New Port Facility Falkland Islands

Supporting statement to variation of condition application

Revision	Date	Description	Prep	Check	App
P02	24-Aug-2022	Final for planning submission	MS	RP	MS

Contract No:	Doc No:	Status	Revision
BAM	BAS.2051	BAS2051-RHD-ZZ-ZZ-FN-YE-5037	S4	P02
RHDHV	PB7829	PB7829-RHD-ZZ-ZZ-FN-YE-5037	S4	P02

QUAY AND CAUSEWAY ELEVATIONS DRAWING

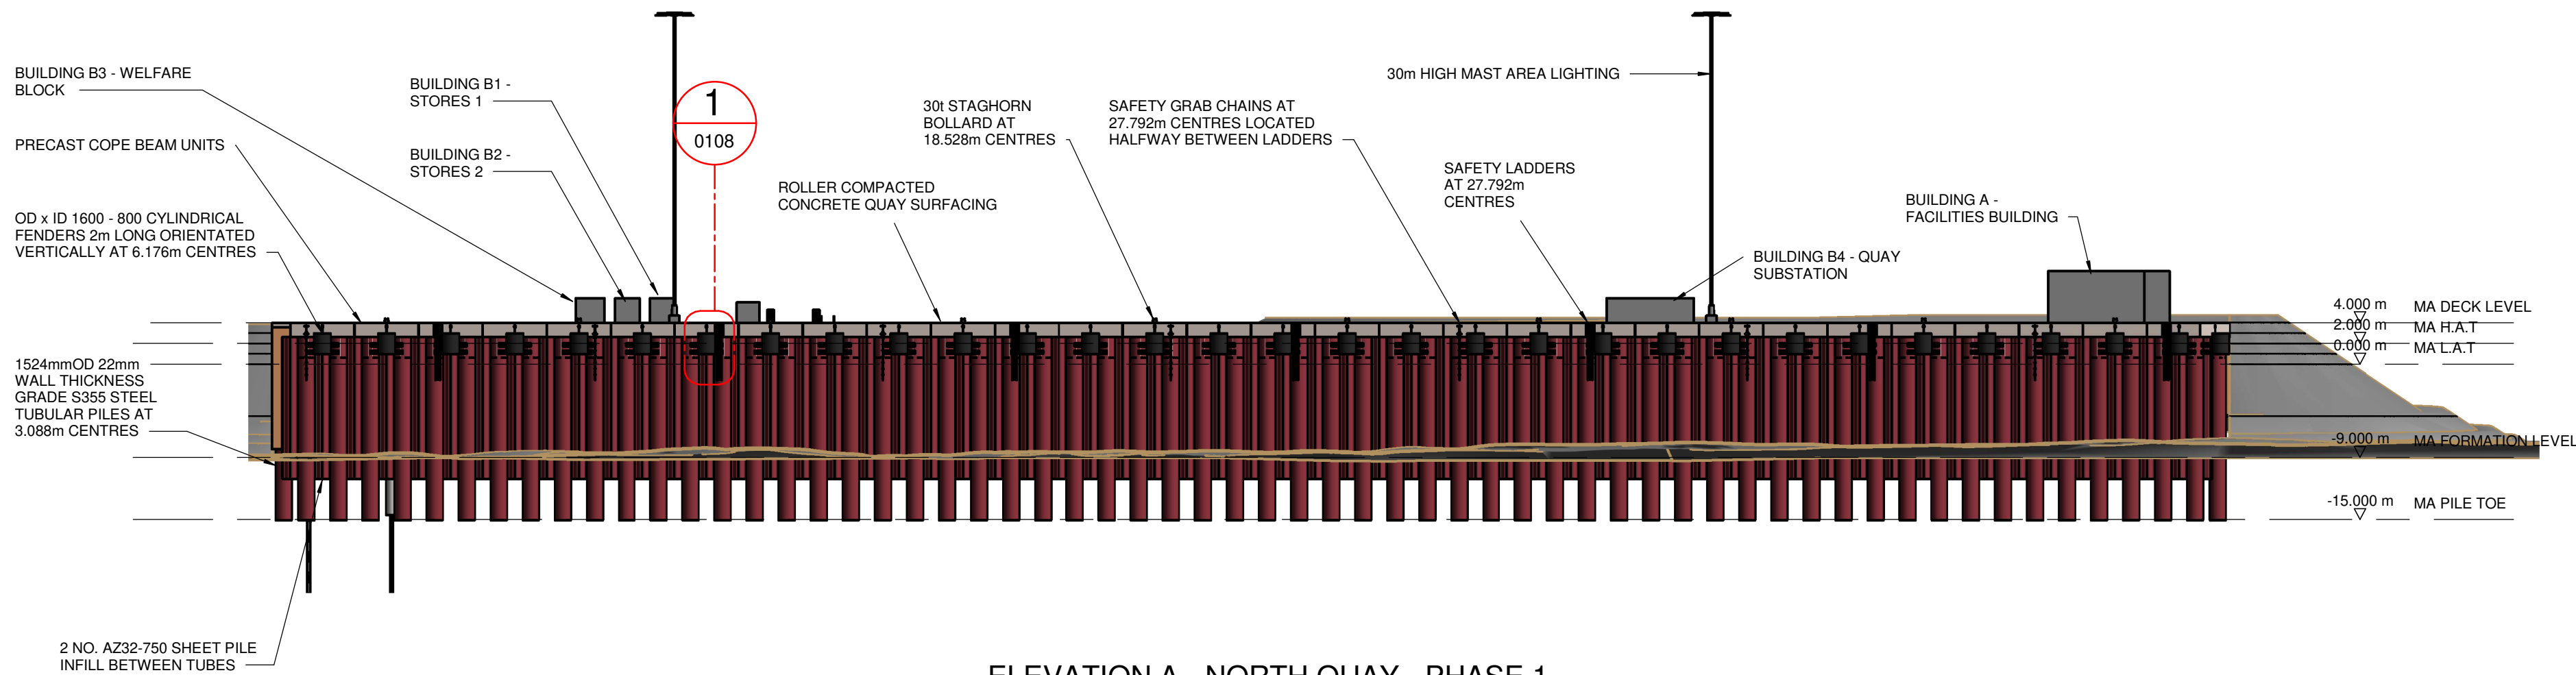
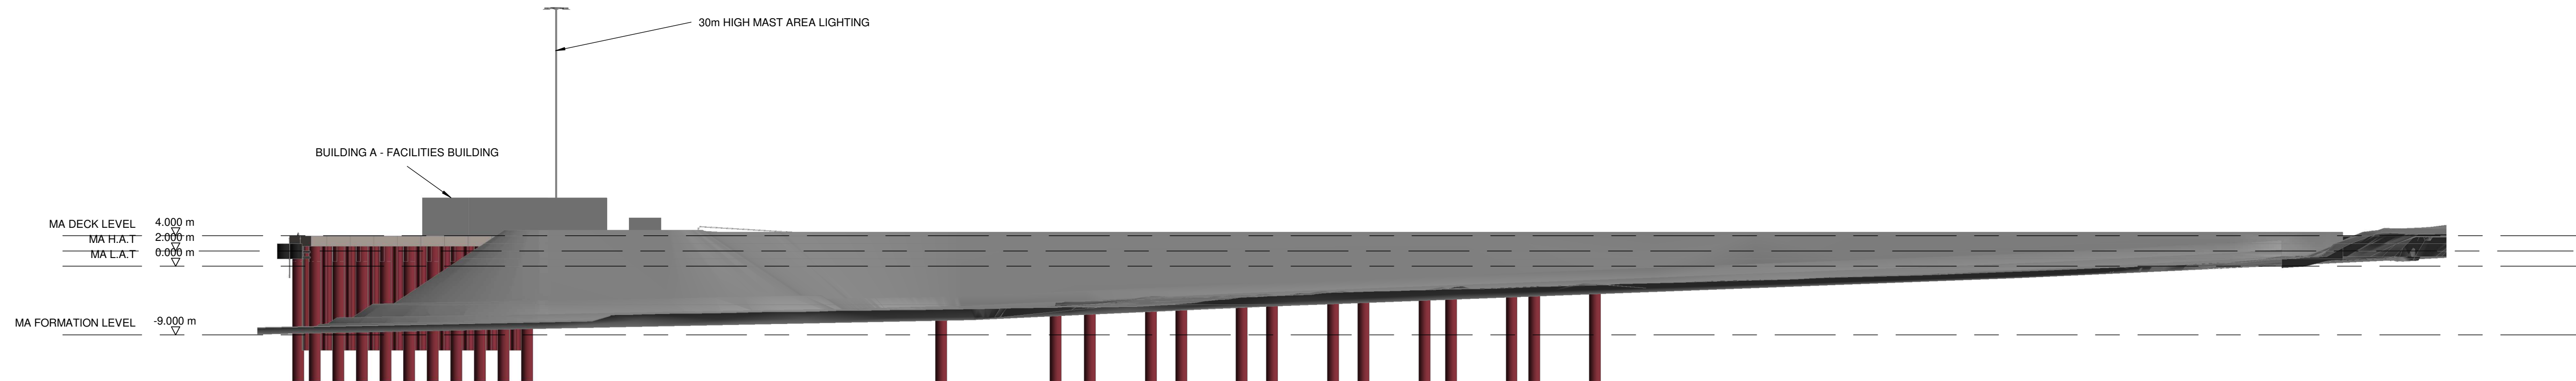
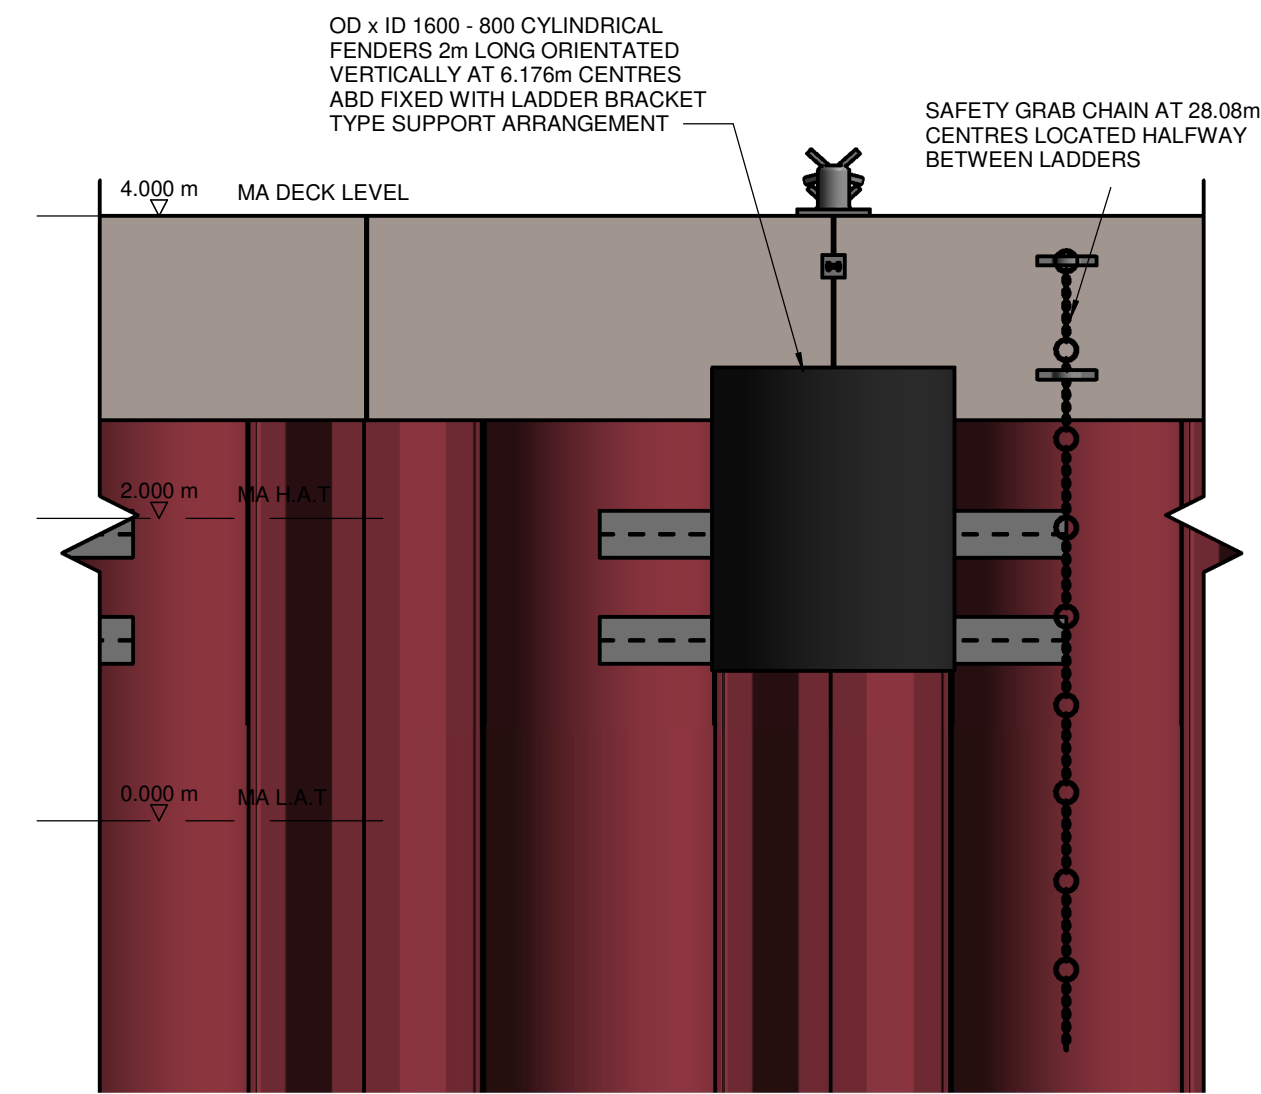
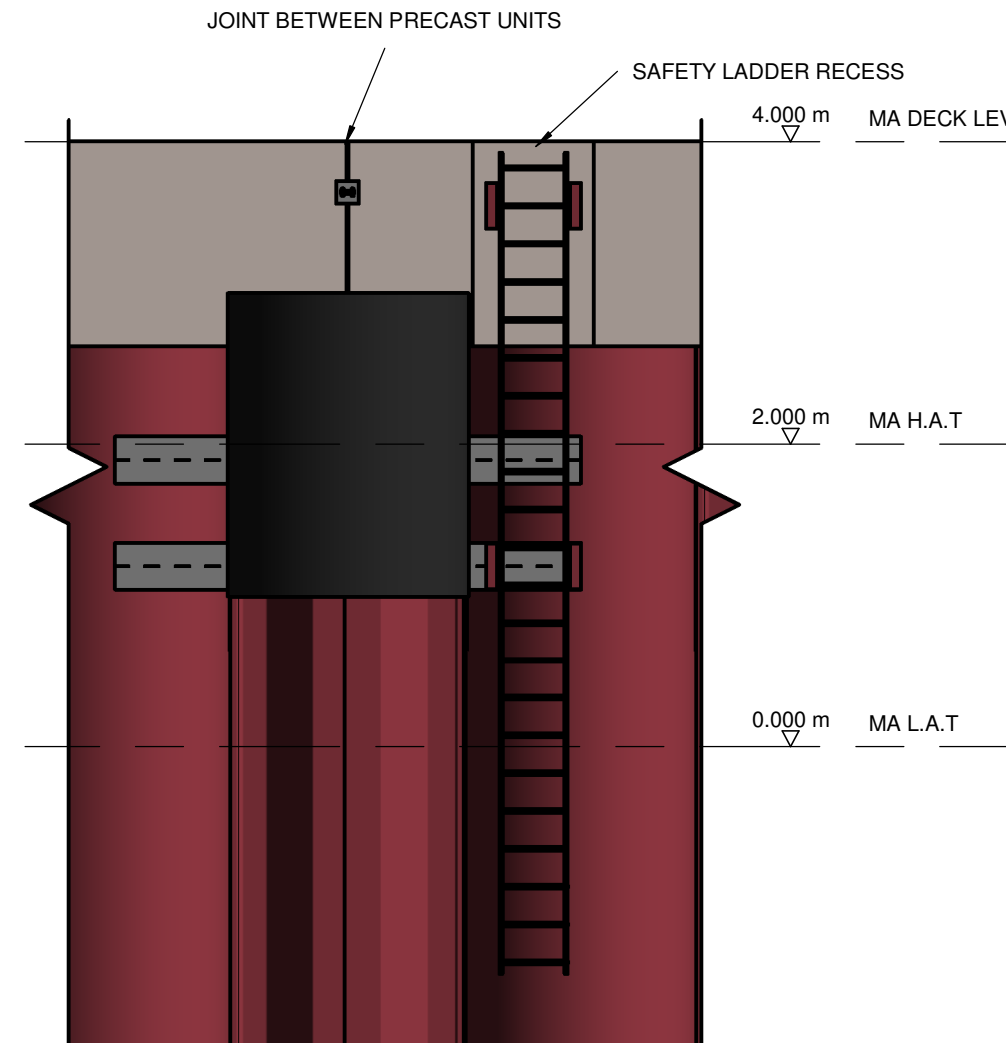
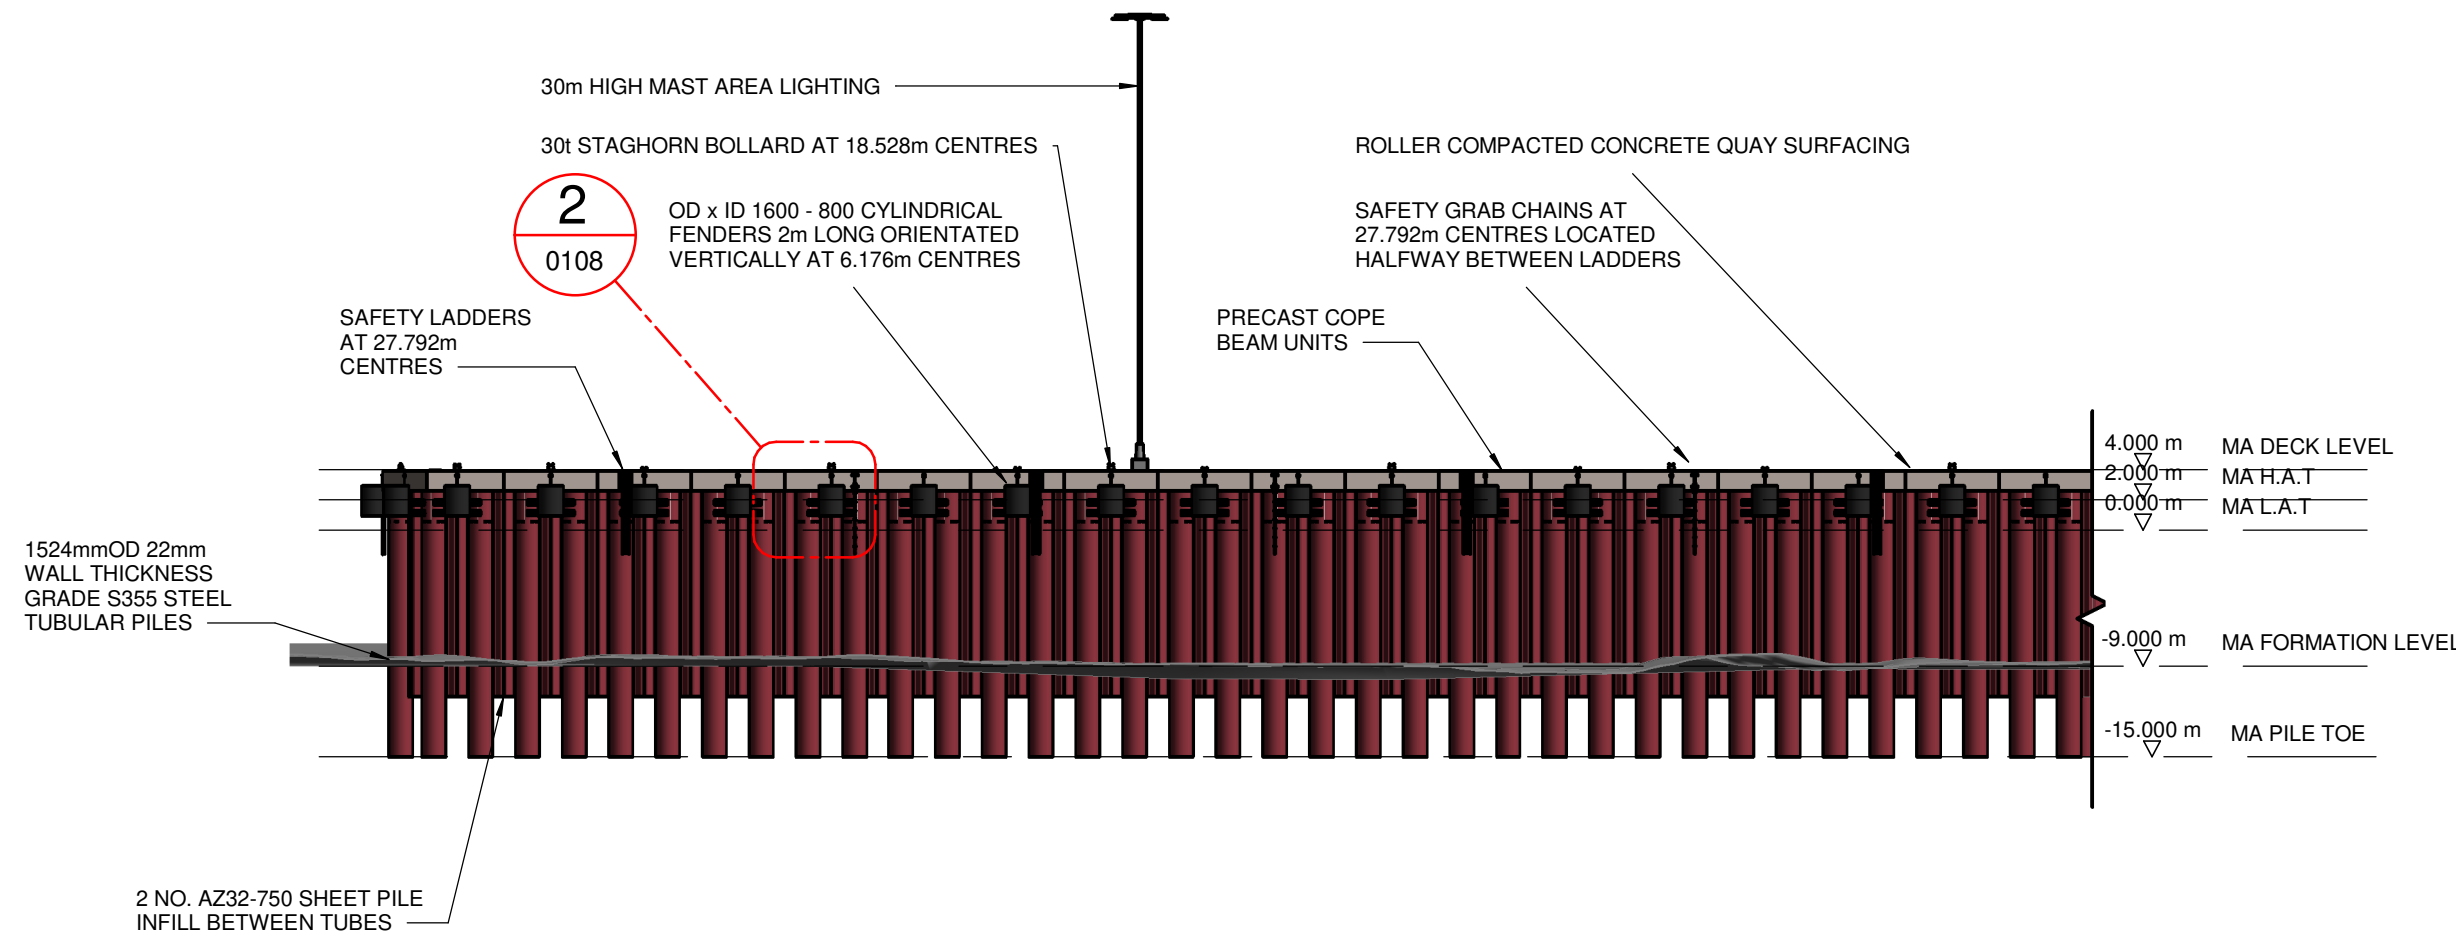
Variation to	Details	Primary condition or content affected
Working platform	It is now proposed that some of the FIPASS barges will be used as working platforms as opposed to a working platform (bund) being constructed from fill material. The use of barges as working platforms only affects the seaward end of the causeway construction; the barges will not be used to construct the causeway itself.	Condition 2 – Approved Plans
